Subject: UniStar Nuclear Energy, NRC Docket No. 52-016
Supplemental Response to Request for Additional Information for the
Calvert Cliffs Nuclear Power Plant, Unit 3,
RAI No. 281, Part 1: Introduction and Interfaces

**Supplemental Response to NRC Request for Additional Information 281,
Question 01-13,
Calvert Cliffs Nuclear Power Plant, Unit 3,**

RAI No. 281

**Supplemental Response to NRC Request for Additional Information (RAI) 281
Calvert Cliffs Nuclear Power Plant, Unit 3**

Figure 1.0-1A -- Organizational Structure for Items and Issues Related to Nuclear Safety, Security and Reliability, Pursuant to the Negation Action Plan

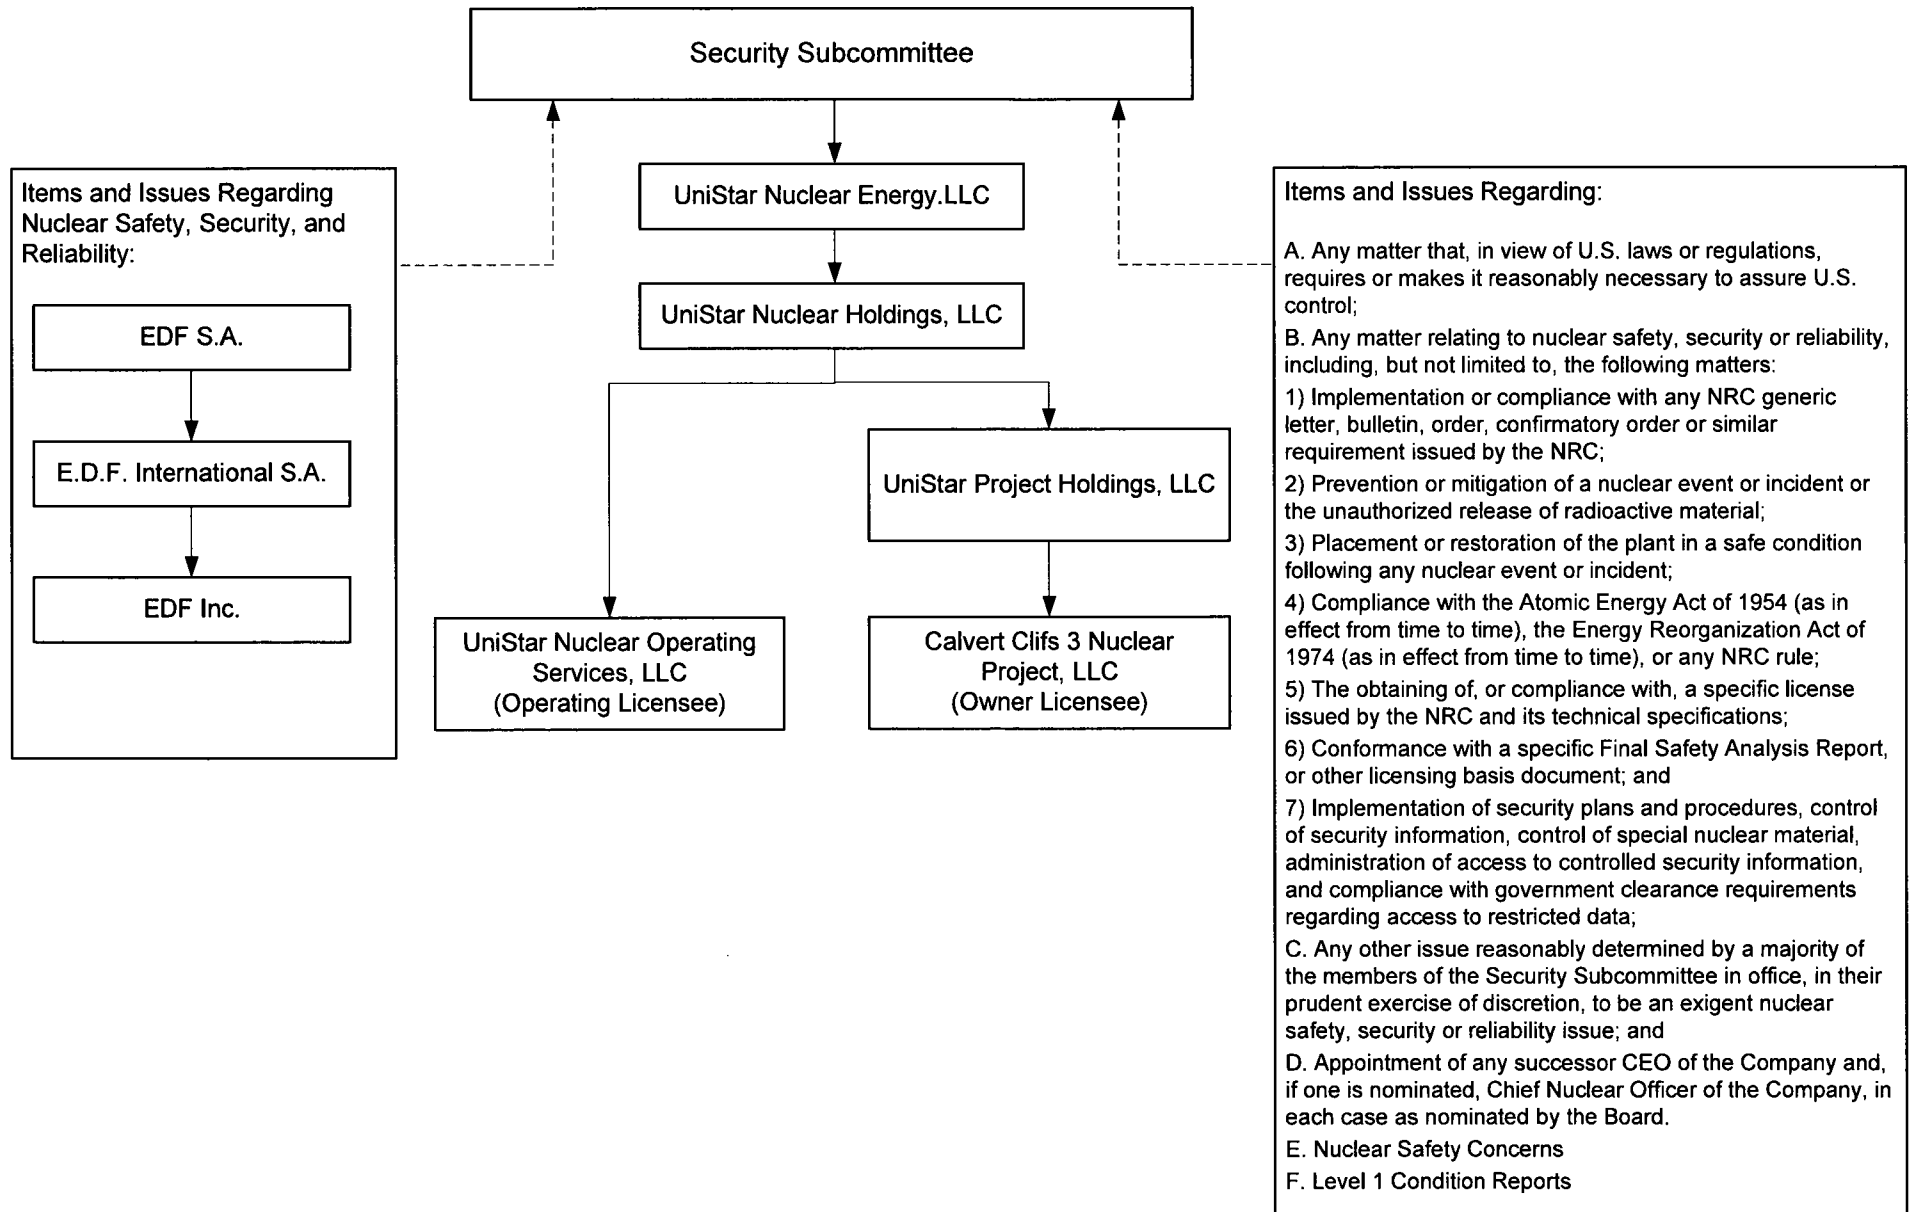
In our previous response to RAI 281¹, UniStar Nuclear Energy provided two organization charts (COLA Part 1 Figure 1.0-1 and FSAR Figure 13.1-1) which, upon further review, have been deemed to be incomplete (and potentially implying inaccurate information) on the role of the Security Subcommittee in preventing foreign ownership control and domination (FOCD).

Enclosure 2 provides new figures for COLA Part 1 and FSAR Section 13.1 that explicitly depict the autonomy of the Security Subcommittee.

The organization charts identified in Enclosure 2 (COLA Part 1, Figure 1.0-1A and COLA Part 2, Figure 13.1-1A) depicting the role of the Security Subcommittee will be incorporated into a future COLA revision.
